Project #20-015
Bruno's Alpine Apartments
Located at approximately 674 East 700 North

Project Name: Bruno's Alpine Apartments
Proponent / Owner: Center Street Architects / Rinchey Johnson Real Estate LLC
Project Address: 674 East 700 North
Request: Design Review Permit
Current Zoning: Campus Residential (CR)
Type of Action: Quasi-Judicial
Hearing Date: March 12, 2020
Submitted By: Russ Holley, Senior Planner

Staff recommends that the Planning Commission **conditionally approve** a Design Review Permit for Project #20-015, Bruno's Alpine Apartments, in the Campus Residential (CR) zone located at approximately 674 East 700 North, TIN #06-052-0018; -0019.

DESIGN REVIEW

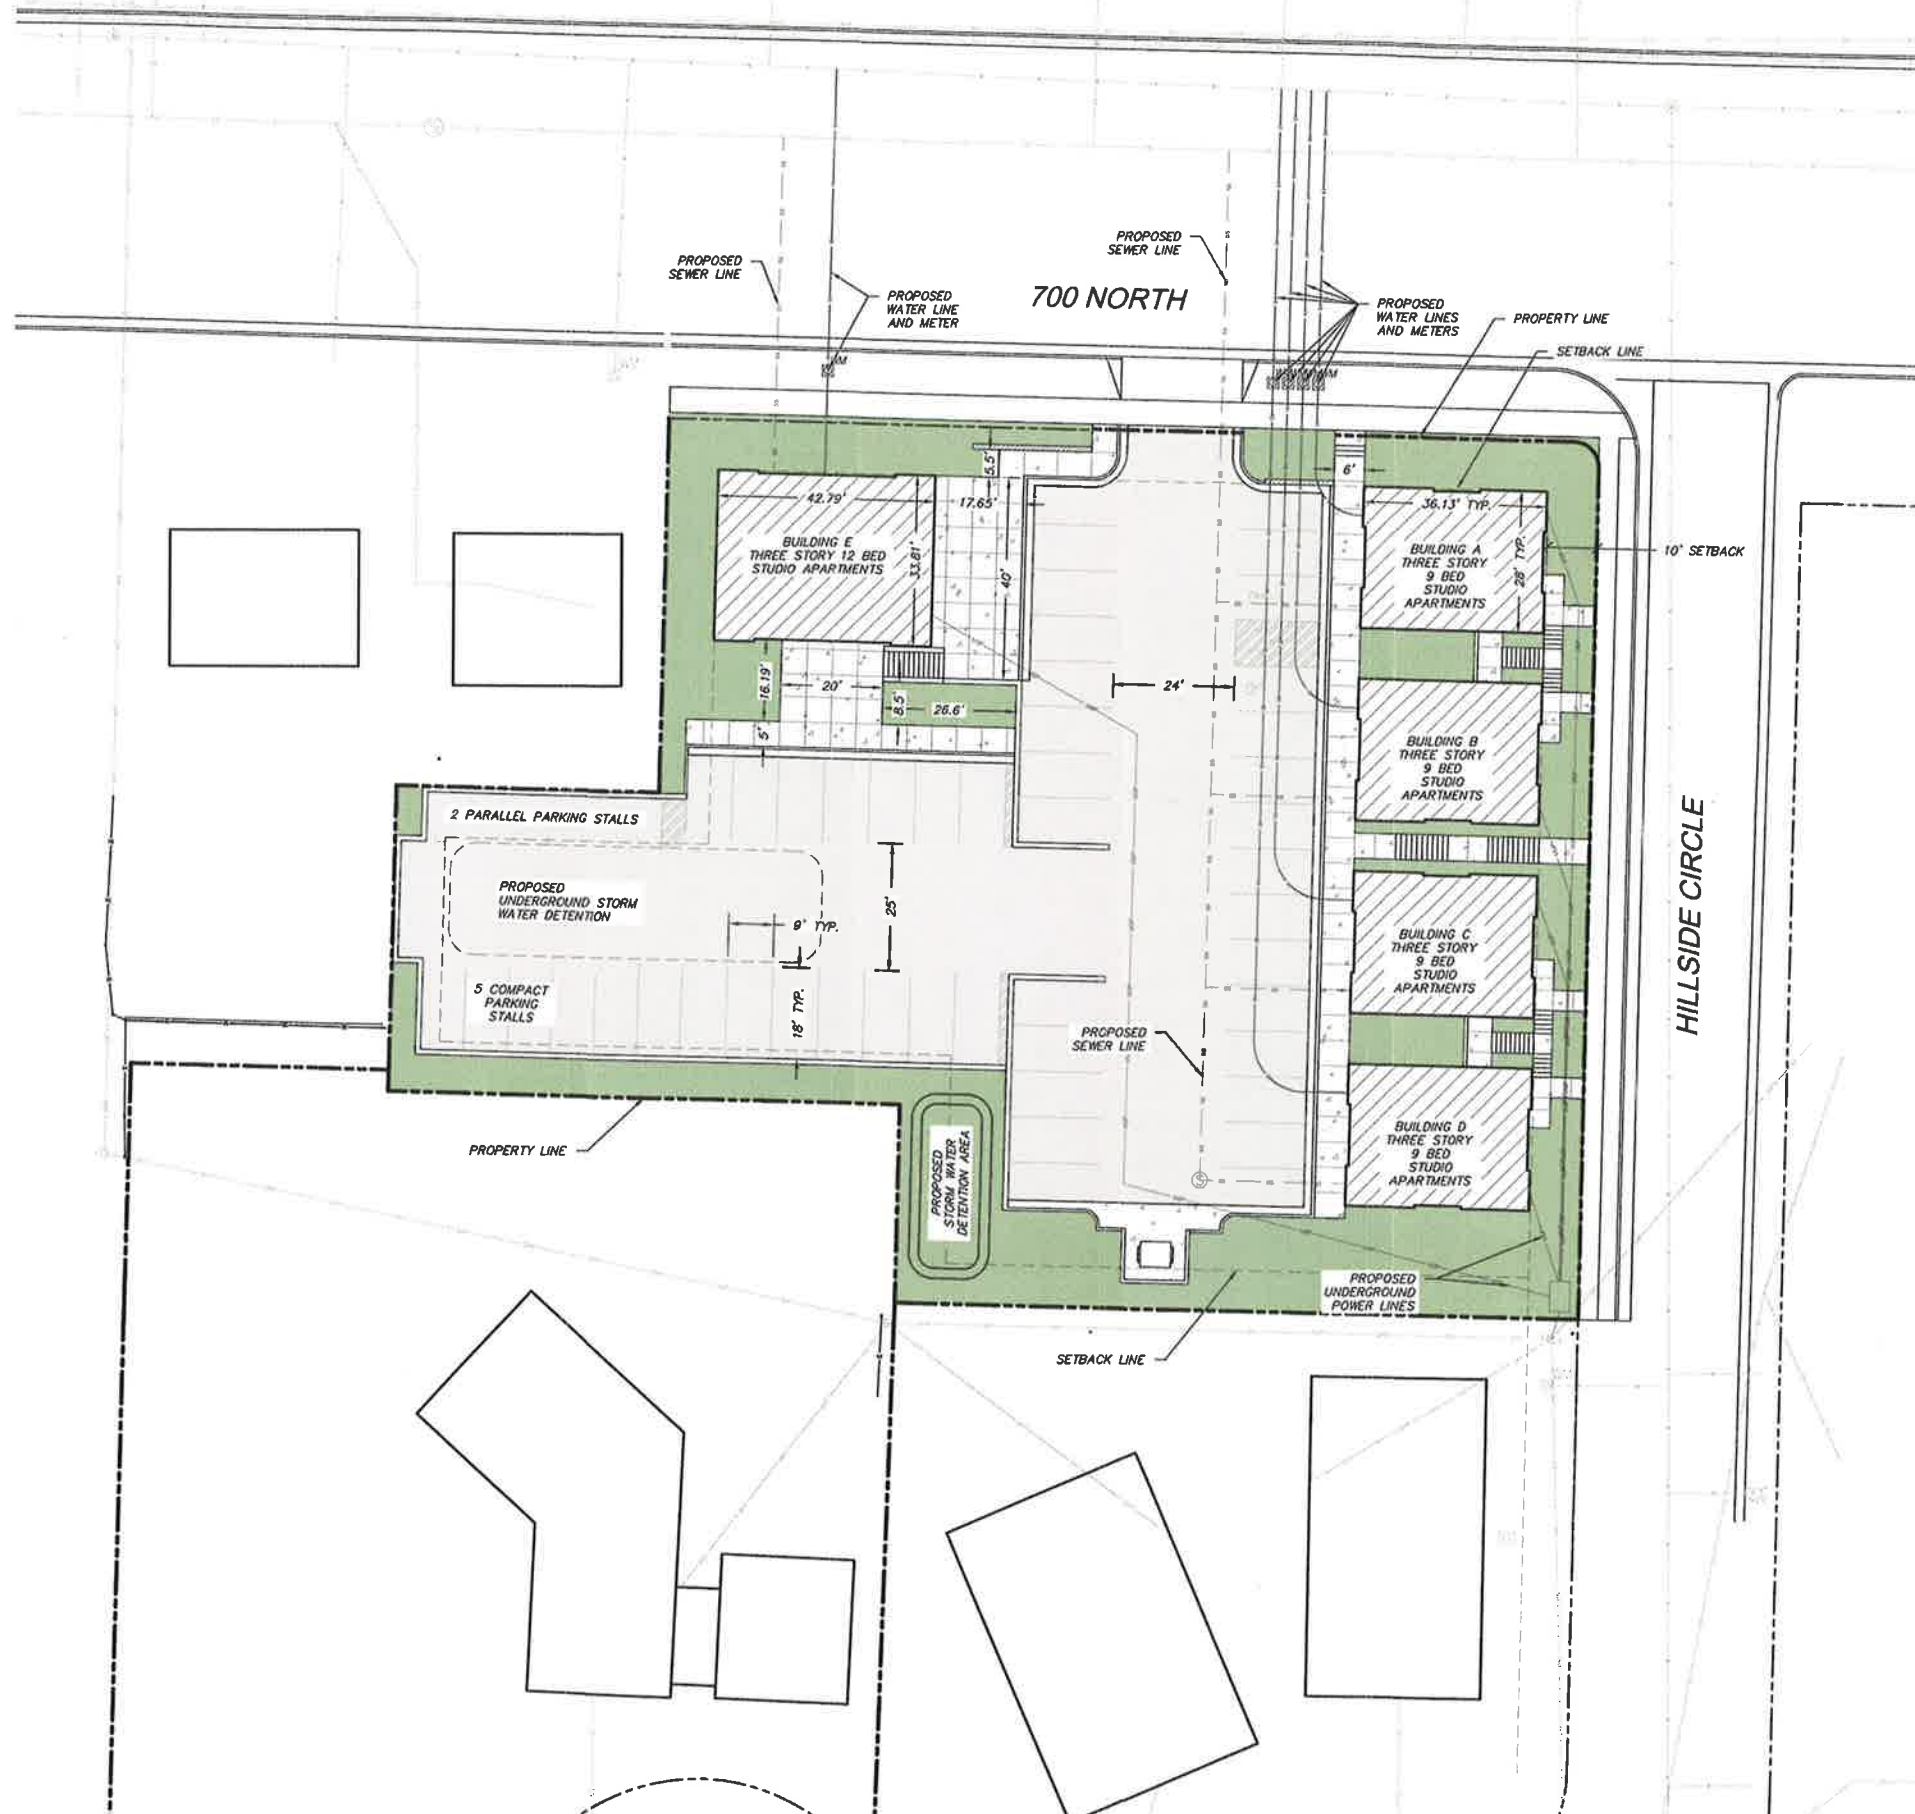
As proposed, a portion of the rear parking lot on the west side, two parallel parking stalls are shown with a two-foot setback to the property line. As conditioned with parking setbacks adjusted to meet minimum standards, the project meets the requirements in the LDC.

3. Side and rear parking lot setbacks shall be a minimum of 5 feet along the perimeter of the surface parking lot.
4. The comprehensive building frontage along the streets shall be increased from 55% to 75%.

5. The project shall provide one parking stall per occupant. A lockable bike rack shall be installed with a capacity of 24 bikes.
6. Unless deemed impractical by the Planning Commission, the building along 700 North shall have an entrance installed on the street-facing façade with a convenient sidewalk connection to the street.

14. Surface storm-water retention and detention facilities shall be located in areas away from public streets and buffered from view.
15. Prior to issuance of a Building Permit, the Director of Community Development shall receive a written memorandum from each of the following departments or agencies indicating that their requirements have been satisfied:
